July 3, 2020

Re: Forwarding Notice – New and Amended Alberta Reliability Standard Definitions:

- 1) Proposed new “radial circuit”;
- 2) Proposed new “system access service” and
- 3) Proposed amended “bulk electric system”

Stakeholder Comment and AESO Replies Matrix – July 23, 2019

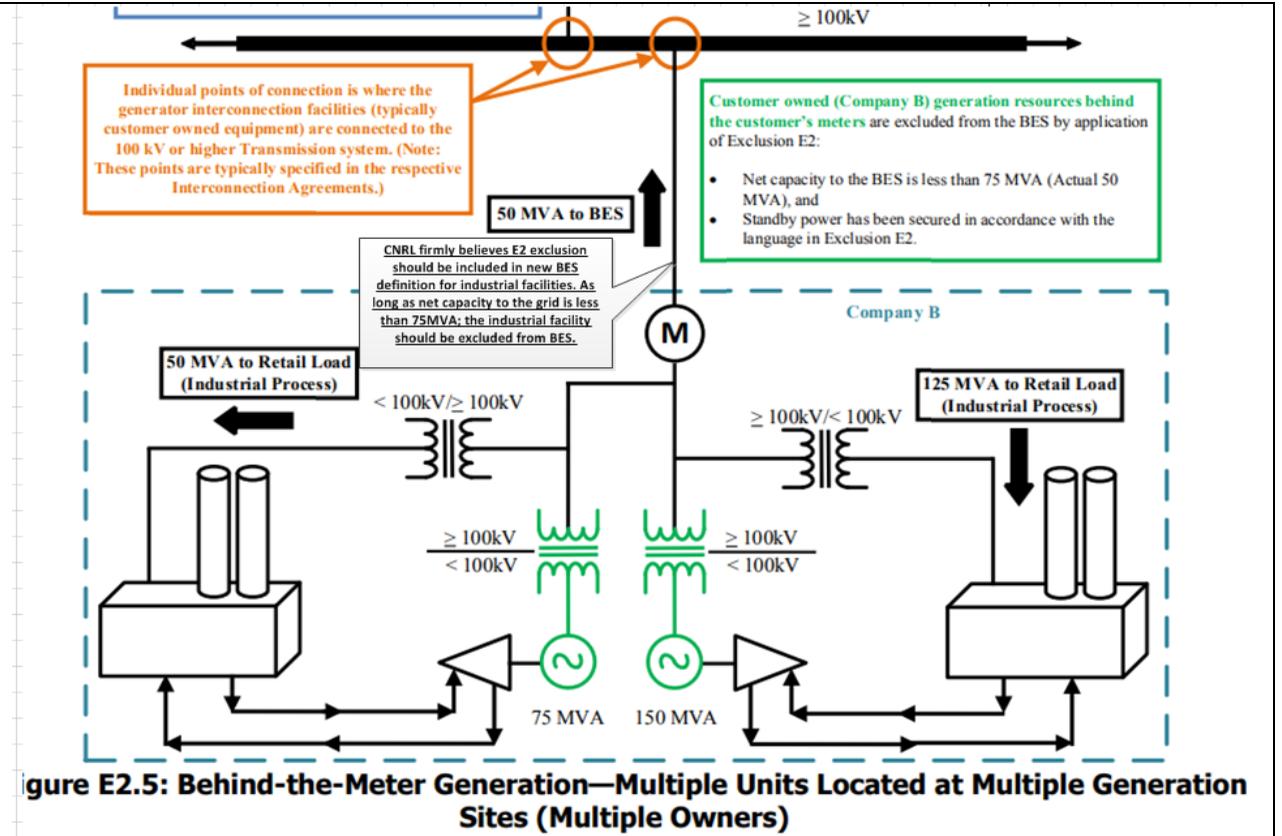
Definitions – New		
Existing	Proposed	Stakeholder Comments and/or Alternate Proposal
No definition currently exists for use in the Alberta reliability standards	<p>“radial circuit” means an arrangement of contiguous system elements energized at 50 kV or higher that:</p> <p>(a) extend from a system element on the networked transmission system in a linear or branching configuration;</p> <p>(b) connect to one or more of a load facility, a generating unit, or an</p>	<p><i>Comment # 1: CNRL understands that the proposed definition sufficiently represent different radial connection arrangement between typical distribution facility interconnection with transmission but it does not take in to account some following specific arrangements many industrial facilities have to improve reliability:</i></p> <ul style="list-style-type: none"> - <i>(c) Industrial facilities are connected to the transmission via a dual circuit, a second parallel line is added for the purpose of improving system reliability while any single line is capable of handling full load and fault current. These facilities should also be considered radial.</i> - <i>(c) Industrial facilities are connected to the transmission via dual circuit where the second circuit is purely for redundancy purposes. The flow of power is always unidirectional on the two circuits (i.e. power always flows in the same direction on the dual circuits). CNRL believe that this type of dual circuit connection should be considered radial since the power flow is always in the same direction on the two circuits and the 2nd circuit is purely for redundancy purposes.</i>

<p>CNRL Requests:</p> <ol style="list-style-type: none"> Point (b) should be modified to include “dual parallel circuits provided any single line is capable of handling 100% of load and that power cannot flow in opposite directions on the two circuits simulataneously”. Point (b) should be modified to include “connect to one or more of a load facility, one or more generating units with net capacity to the BES of less than a (suitable MVA limit), or an aggregated generating facility”; and
<p>No definition currently exists for use in the Alberta reliability standards</p>	<p>“system access service” as defined in the Act means the service obtained by market participants through a connection to the transmission system, and includes access to exchange electric energy and ancillary services.</p>

<p>Canadian Natural Resources Limited (“CNRL”)</p> <p>2. CNRL understands that the proposed definition sufficiently represent different radial connection arrangement between typical distribution facility interconnection with transmission but it does not take in to account some following specific arrangements many industrial facilities have to improve reliability:</p> <p>- (c) <i>Industrial facilities are connected to the transmission via a dual circuit, a second parallel line is added for the purpose of improving system reliability while any single line is capable of handling full load and fault current. These facilities should also be considered radial.</i></p> <p>- (c) <i>Industrial facilities are connected to the transmission via dual circuit where the second circuit is purely for redundancy purposes. The flow of power is always unidirectional on the two circuits (i.e. power always flows in the same direction on the dual circuits). CNRL believe that this type of dual circuit connection should be considered radial since the power flow is always in the same direction on the two circuits and the 2nd circuit is purely for redundancy purposes.</i></p>	<p>2. The AESO has assessed the NERC guidance information on the application of radial circuits in the NERC BES definition and the AESO is of the opinion that maintaining consistency with the NERC guidance information is appropriate.</p> <p>The AESO generally considers the size of the generating unit or aggregated generating facility to be the primary consideration for bulk electric system inclusion rather than the net supply to the transmission system. A large generating unit or aggregated generating facility may significantly impact the reliable operation of the bulk electric system by causing a large instantaneous change in power flow on the system, regardless of the size of its on-site load.</p> <p>Even though the AESO does not consider the circuit configuration described as being a radial circuit, it does recognize that these types of configurations should be considered when</p>
